# Comments and Responses Report: Public Participation on Draft Scoping Report Proposed Granger Bay Precinct Development at the V&A Waterfront

DEA&DP REF: 16/3/3/2/A7/4/3051/25

DATE: 15 January 2026

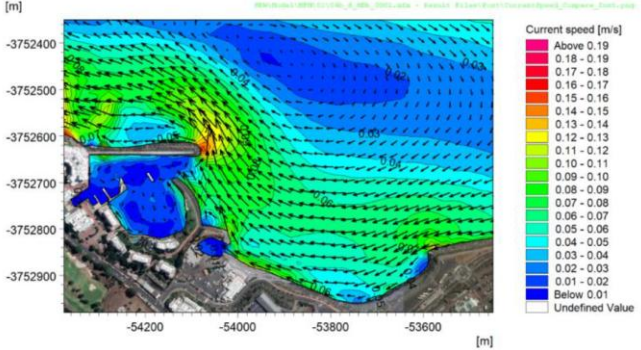
Date	Method	Name	Interest	Comment / Query	Response
				<p>This response is submitted on behalf of the Waterclub Berthholders Association (BHA), which manages and operates the Waterclub Marina. The marina lies within 200 metres of the planned V&amp;A development and comprises three major jetties, associated walkways, electrical and water services, and 74 privately owned moorings.</p> <p>It appears that no notice has been given to berth owners—whether residents or third-party owners—whose property rights and asset values stand to be affected.</p>	<p>EIA Report, where relevant and appropriate.</p> <p>The submission of comments on behalf of the Berthholders Association is noted. There are no public records that indicate that the Marina is operated by a separate entity to the Waterclub itself, nor that any moorings may be registered as owned separately from the Waterclub itself – thank you for bringing this to our attention. In earlier engagements with Ms Ponton the impression had been given that the management of the Water Club Association had undertaken to notify all owners on behalf of the EAP, since the sharing of contact information for individual owners was not consistent with the provisions of the Protection of Personal Information Act, 2013. We also note that on 11 August 2025, we received email confirmation from Ms Ponton that the notification of the pre-application public participation process had been 'immediately forwarded to all registered owners'. Media and site notices, together with significant public media attention to the public participation process, will have aided in drawing the attention of all potential interested and affected parties to the opportunity to comment and register as I&amp;APs.</p>

<p><b>2. Overview</b></p> <p>Separate and apart from the defective notice issue, the Draft Scoping Report suffers from a fundamental evidentiary gap:</p> <ul style="list-style-type: none"> <li>• No bathymetric study of the marina appears to have been undertaken; and</li> <li>• No request was made to the BHA to supply its historic bathymetric records.</li> </ul> <p>No explanation is provided for these omissions.</p>	<p>The PRDW Wave and Hydrodynamic Modelling Report (Appendix G to the Scoping Report) includes a bathymetric survey for the model</p>

Date	Method	Name	Interest	Comment / Query	Response
				<p>The BHA has, at its own cost, commissioned an updated bathymetric study, assessed alongside previous surveys. The most recent report demonstrates significant re-silting over the past four years, raising serious concerns about how the proposed development may alter sedimentation dynamics.</p> <p>The Atlantic Seaboard is characterised by a notable longshore sediment flow, with accumulation occurring predominantly in sheltered areas. The Waterclub Marina, being sheltered, naturally accumulates finer sands and silts and therefore requires periodic dredging.</p> <p>Accordingly, the BHA must formally request that the V&amp;A and its consultants provide detailed information on the expected sedimentation impact as part of the Public Participation Process.</p>	<p>domain, dated 2022, and including the Granger Bay Marina.</p> <p>That the marina is subject to sediment buildup is also noted in the above report, which describes a 'muddy' seabed within the Water Club marina, and concludes that under the baseline scenario (i.e. without the proposed reclamation and development), longer-term mud accumulation is predicted within the entire inner area of the Waterclub, except for the entrance and some localised areas of scour induced by strong currents due to harbour resonance. This result is described by PRDW as consistent with bathymetric surveys of the Waterclub and historical dredge records, which indicate that periodic maintenance dredging of the Waterclub has been required.</p> <p>The modelled scenario including the proposed development indicates that the development will not result in significant impacts on the bed shear stresses in the Waterclub marina, and thus that no additional mud accumulation and no additional volume of maintenance dredging is predicted for the Waterclub.</p> <p>Please refer to pp 43-44 of the PRDW report (Appendix G to the Scoping Report) for further details.</p>
